REFERENCE NHSTA RECALL # 14E015.

VILLA INTERNATIONAL				
ISS LINK ASSEMBLY, RECALL FIX				
jgm 4.18.14	SIZE	FSOM NO.	DWG NO.	REV
	SCALE		03

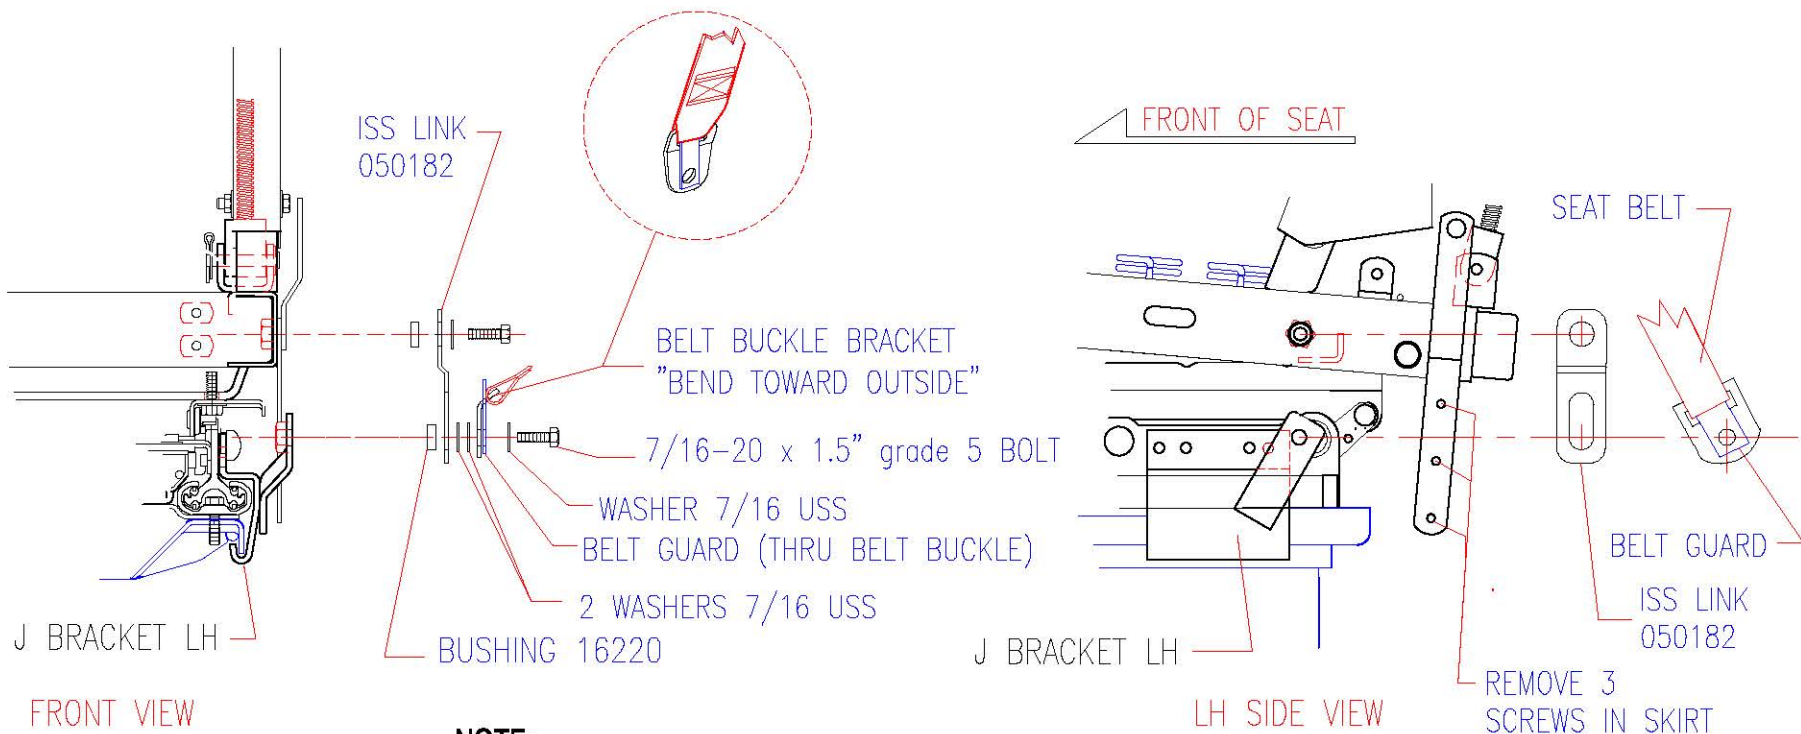
NOTE:
 REMOVE TWIST IN SEAT BELT BEFORE FASTENING END.

LEFT SIDE OF DRIVERS SEAT SHOWN
 RIGHT SIDE PASSENGER SEAT THE SAME.

A BUSHING 16620 IS ALSO INSTALLED ON THE
 OPPOSITE SIDE LINK.
